Interactive comment on “Measuring variations of $\delta^{18}\text{O}$ and $\delta^2\text{H}$ in atmospheric water vapour using laser spectroscopy: an instrument characterisation study” by F. Aemisegger et al.

Replies to the comments from referee 2

Fig. 1.

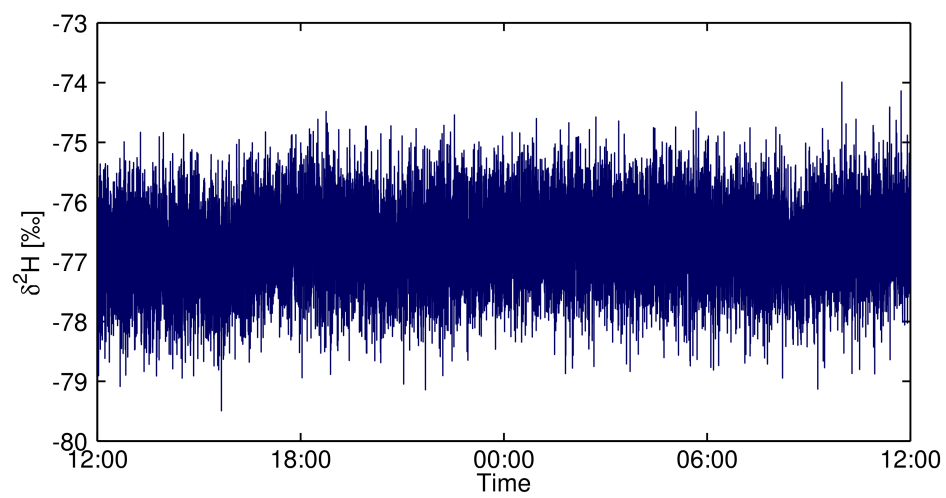
a) It would be most instructive to present the Allan plots of Figure 8 together with the time series data used for its calculation. In fact, for anybody who has generated such figures him- or herself it is evident that the shape of the curve depends, sometimes significantly, on the exact beginning and end point of the time series, as well as its exact length.

b) The curves tend to change from measurement to measurement, which is not captured in the given plots, as they lack an error estimate. In the absence of a proper, analytical error estimate the best one can do is to calculate the Allan deviation for a linear instead of logarithmic time step. Although in the latter case neighboring data points will be correlated, at least the spread in the Allan deviation values becomes visible. Including a correct estimate of the error on the determination of the (minimum) Allan deviation will have repercussions for the “optimal” numbers reported in Table 6, which are without a doubt too optimistic. In fact, a hint of this is given by the sharp and very fast fluctuations seen in figure 9. Some of the fast and large changes in the “bias correction” value appear to occur on a time scale comparable to that of the optimum averaging times reported in Table 6. If such a sharp transition were included in the time series used for the calculation of Figure 8, the reported short-term precision would be rather worse.

We do not think that such a plot gives much information to the reader. We performed

an Allan test and chose the stationary part of the measurements, i.e., the period when the calibration system was in steady state. We of course left out the start and the end of the calibration run to avoid any influence from the calibration unit warm up or valve switch. The goal here is to characterise the instrument precision and drift in an ideal set up. The following figure shows the $\delta^2\text{H}$ measurements by L1115-i:

We changed the Allan plots. Fig. 8 now shows the Allan deviations computed with a linear time step. We adapted the optimal numbers of Table 6 and in the text.
